10/810,773

Jasna Roeth

Office Action Summary

DETAILED ACTION

Fig. 7

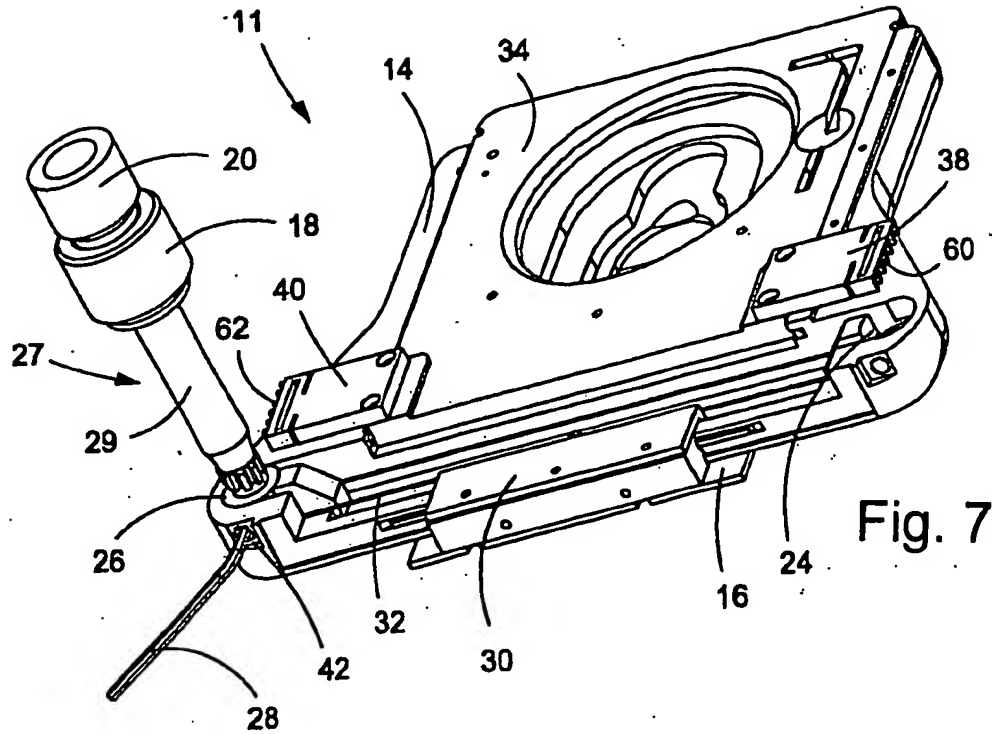
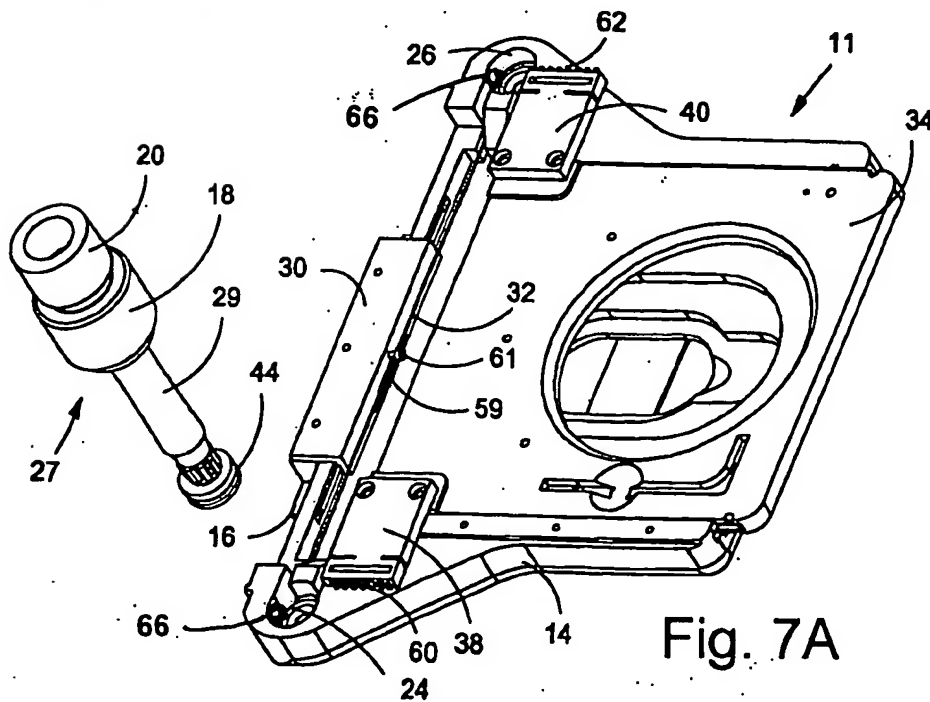
1. The replacement drawings were received on 7/3/06. These drawings are acceptable.

Drawing Changes
Approved
acc
8/23/06
